**DEPARTMENT OF TRANSPORTATION**

Contract #: 04-0120F4Cty: SF/ALA Rte: 80 PM: 13.2/13.9File #: 69.25B**QUALITY ASSURANCE -- NON-CONFORMANCE REPORT****Location:** Changxing Island, Shanghai, P.R. China**Report No:** NCR-000725**Prime Contractor:** American Bridge/Fluor Enterprises, a JV**Date:** 01-May-2010**Submitting Contractor:** Zhenhua Port Machinery Company, Ltd (ZPMC), Changxing Island**NCR #:** ZPMC-0688**Type of problem:**

**Reference Description:** Missed MT Indications by QC in OBG Segment 9DW**Description of Non-Conformance:**

**Job Name:** SAS Superstructure

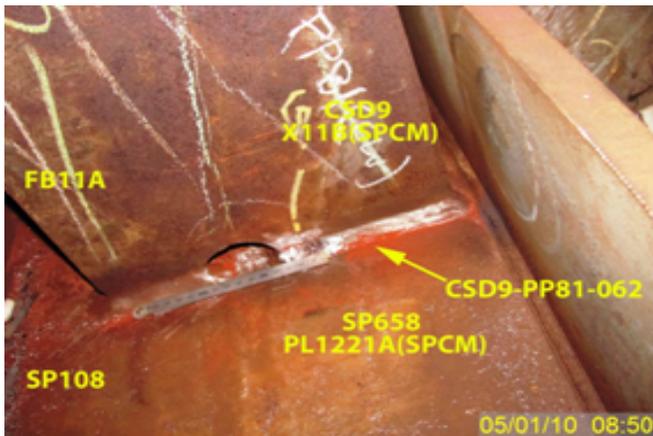
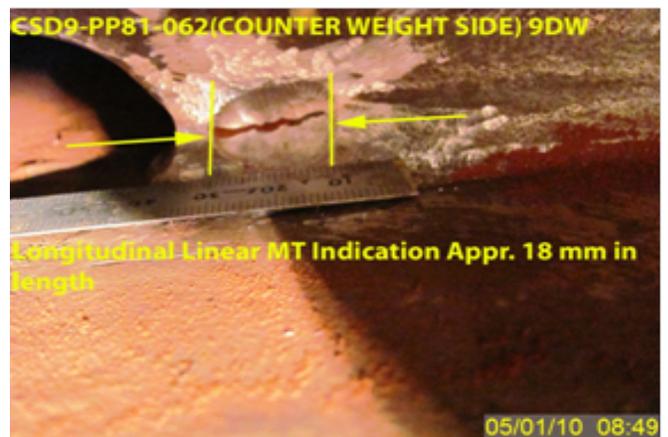
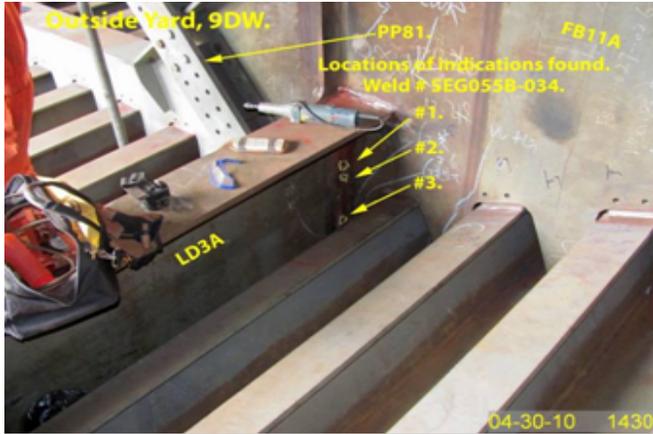
During the Quality Assurance (QA) Magnetic particle Testing (MT) review of welds located on Orthotropic Box Girder (OBG) Segment 9DW, this QA Inspector discovered the following issue:

- Three transverse linear indications, one measuring approximately 9mm and two indications measuring approximately 5mm in length at Longitudinal Diaphragm (LD) LD3A to Floor beam (FB) FB11A.
- Weld is identified as SEG055B-034 and designated as a Fracture Critical Weld (FCW).
- The weld is a 14mm Complete Joint Penetration (CJP) T-joint joining LD 3A shear plate identified as X39B to FB web plate identified as X47C (Seismic Performance Critical Material SPCM).
- The indications are clearly marked on the material.

- One (1) Longitudinal linear indication measuring approximately 18mm in length.
- The Y location is 7mm from the cope hole.
- The indication is clearly marked on the material near the weld.
- The weld is identified as: CSD9-PP81-062.
- The weld is designated as Seismic Performance Critical Member (SPCM).
- The weld is located at PP81 (Counter Weight Side).
- The weld is a Fillet Weld T-joint joining the Corner Assembly Diaphragm identified as X11B (SPCM) to Side Plate identified as SP658 (SPCM).
- OBG segment 9DW is located west of Bay #14.

The Notice of Witness Inspection Number (NWIT) is 005616. The indication is located inside the area that has been previously tested and accepted by ZPMC Quality Control (QC) personnel. Per the contract documents ZPMC's QC personnel are required to perform 100% MT inspection of this weld.

**Reference Resolution:** ZPMC has repaired the welds in question and is providing NDT documentation to show that the welds are acceptable. Based on this ZPMC requests closure of this NCR.

This proposed resolution is acceptable. The documentation received is sufficient and the Department concurs that Non-Conformance ZPMC-0688 is closed.

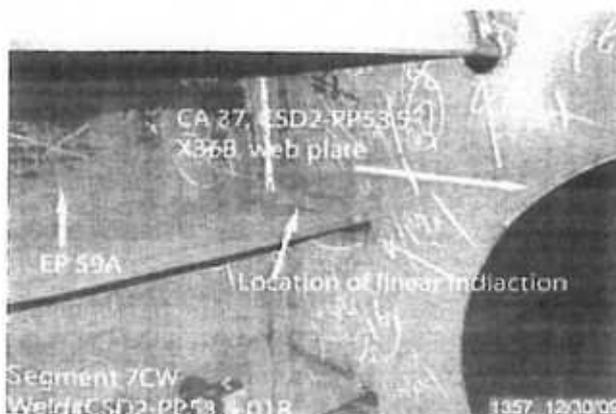
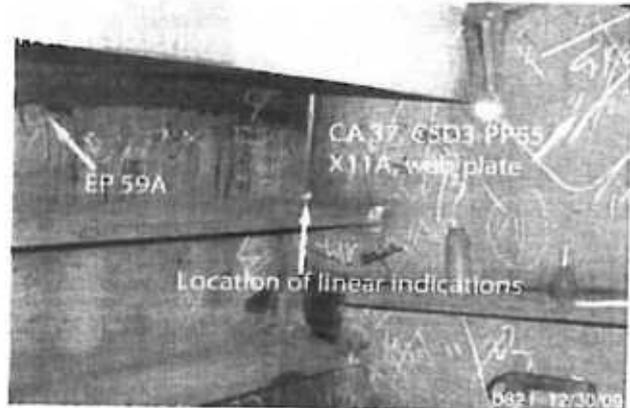
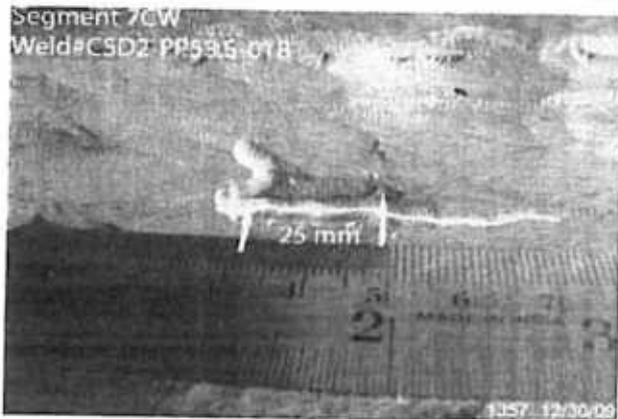
During the Quality Assurance Magnetic Particle Testing (MT) review of welds located on Segment 7CW, this Quality Assurance Inspector (QA) discovered the following issues:

- Two (2) Longitudinal linear indication measuring approximately 20mm and 25mm in length.
- The welds are identified as: CSD3-PP55-025, 026 (30 mm) and CSD2-PP53.5-018 (25 mm).
- The welds are a Fillet Weld type joining the Edge Plate (EP59A) stiffeners to Corner Assembly (CA37A) web plates.
- The OBG 7CW segment is located at in front of Blast Shop.

The Notice of Witness Inspection Number (NWIT) is 004947. The indication is located inside the area that has been previously tested and accepted by ZPMC Quality Control (QC) personnel. ZPMC's QC personnel are required to perform twenty five (25%) percent MT inspection of this weld.

Submit a repair procedure to the engineer for approval. Provide the ZPMC MT technician additional training and equipment to ensure these types of indications are identified in the future.

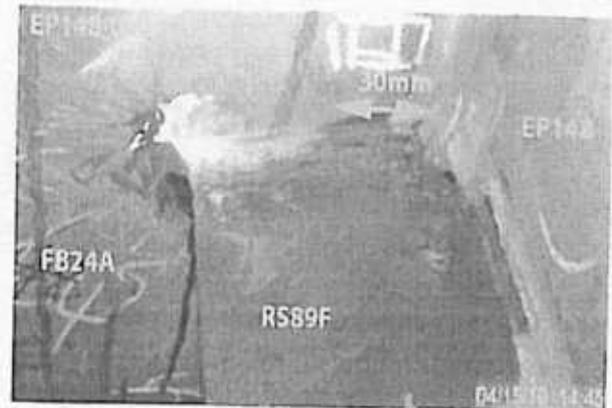
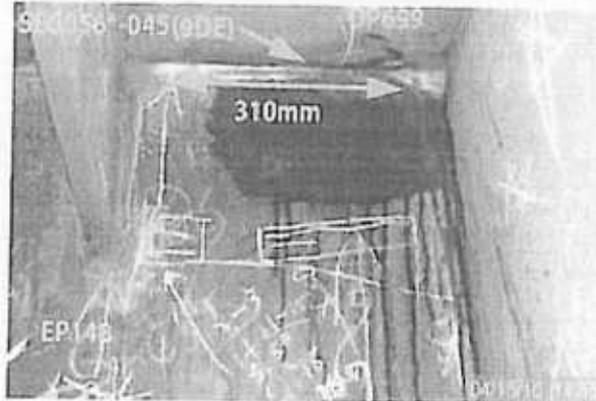
During the Quality Assurance (QA) Ultrasonic Testing (UT) review of welds located on Orthotropic Box Girder (OBG) Segment 9DE, this QA Inspector discovered the following issues:

- Two (2) longitudinal linear indications measuring approximately 310mm and 30mm in length.
- The indications dBs rating are +6 and +4.
- Material thickness is 18mm.
- The depth of the indications is approximately 11mm and 13mm.
- The welds are identified as SEG056\*-045 at Panel Point (PP) PP81.5 and EP148-022 at PP 81.
- The welds are designated as Seismic Performance Critical Material (SPCM).
- The indications are clearly marked on or near the weld.
- The Y distance for the indications are 50 mm from PP81.5 and 0 mm from EP148A.
- Weld SEG056\*-045 is a Complete Joint Penetration (CJP) Corner joint, joining the Edge Plate PL1336C (SPCM) to Deck Plate PL1314A (Non SPCM).
- Weld EP148-022 is a Complete Joint Penetration (CJP) "T" joint, joining the Edge Plate stiffener RS89F (Non SPCM) to FB24A plate PLX24D (SPCM).
- Segment 9DE is located outside of Paint shop.

The Notice of Witness Inspection (NWIT) No. is 005523. The indication is located in an area previously tested and accepted by ZPMC Quality Control (QC) personnel. As per the contract documents, ZPMC's QC personnel are required to perform hundred (100%) percent UT inspection of this weld.

AWS D1.5-02 Section 6; Table 6.3 specifies a class "A" indication as having a rating of 10dBs and under for material thicknesses 8mm through 20mm.

Propose a resolution for the identified non-conformance to prevent future occurrences. A response for the resolution of this issue is expected within 7 days.

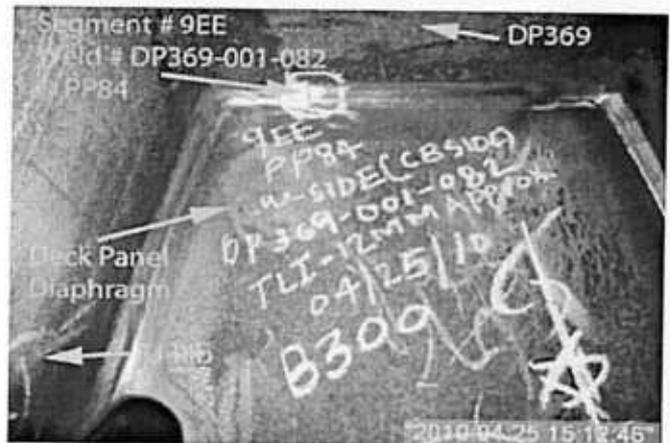
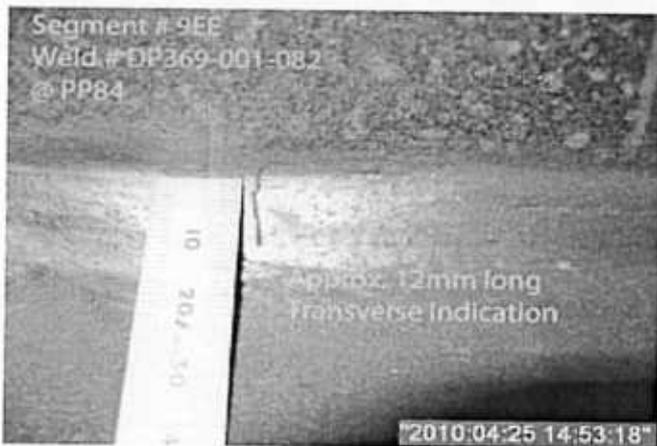
During the Quality Assurance (QA) Magnetic Particle Testing (MT) review of welds located on Segment 9EE, this QA Inspector discovered the following issues:

-One (1) Transverse linear crack like indication measuring approximately 12 mm in length.

-The weld is identified as DP369-001-082 @ Panel Point-084.

-The weld is a Fillet Weld T-joint joining the Deck Plate (DP369) to Deck panel diaphragm plate.

-One (1) Transverse linear indication measuring approximately 10 mm in length.

-Weld is a Complete Joint Penetration (CJP) Weld joining the Deck panel Diaphragm to U-Rib.

-Weld Identification number is DP477-001-137 @ Panel Point-083.

Propose a resolution for the identified non-conformance with revised procedures to prevent future occurrences. A response for the resolution of this issue is expected within 7 days.

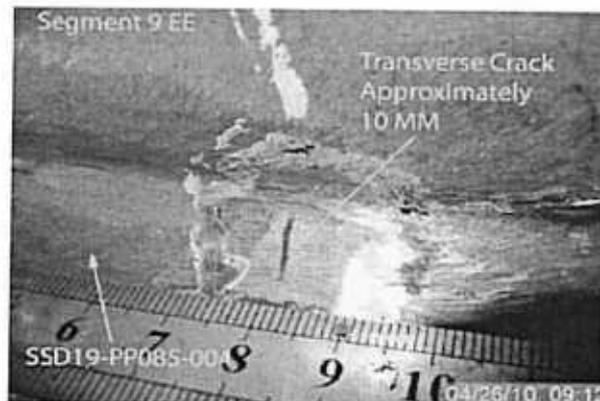
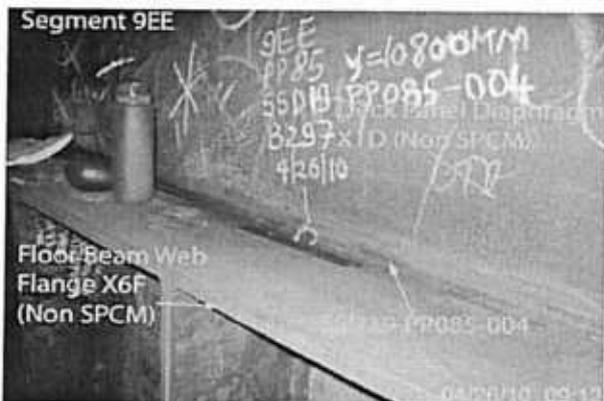
During the Quality Assurance (QA) Magnetic Particle Testing (MT) review of welds located on Segment 9EE, this QA Inspector discovered the following issues:

- One (1) transverse crack measuring approximately 10mm in length in the fillet weld joining the Deck Panel Diaphragm (X1D) to Floor Beam Web Flange (X6F) at panel point 85.
- The Y location is 10800mm from the termination of the weld on the crossbeam side.
- The indication is clearly marked near the weld.
- The weld is identified as: SSD19-PP085-004.
- OBG segment 9EE is located north of the blast shop.
- The Notice of Witness Inspection Number (NWIT) is 005583. The indication is located within the area that has been previously tested and accepted by ZPMC Quality Control (QC) personnel.

Propose a resolution for the identified non-conformance with revised procedures to prevent future occurrences. A response for the resolution of this issue is expected within 7 days.

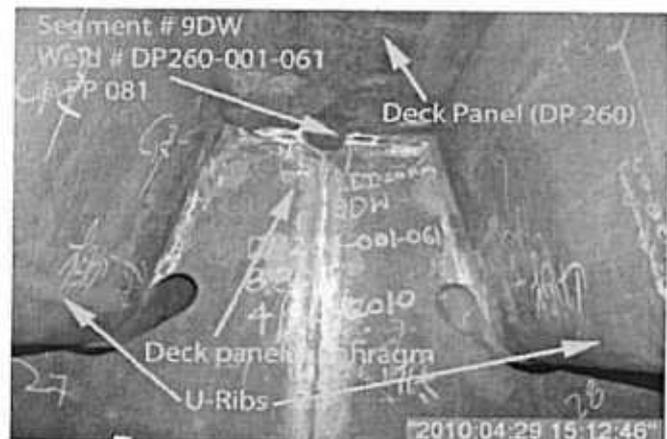
During the Quality Assurance (QA) Magnetic Particle Testing (MT) review of welds located on Segment 9DW, this QA Inspector discovered the following issue:

Propose a resolution for the identified non-conformance with revised procedures to prevent future occurrences. A response for the resolution of this issue is expected within 7 days.
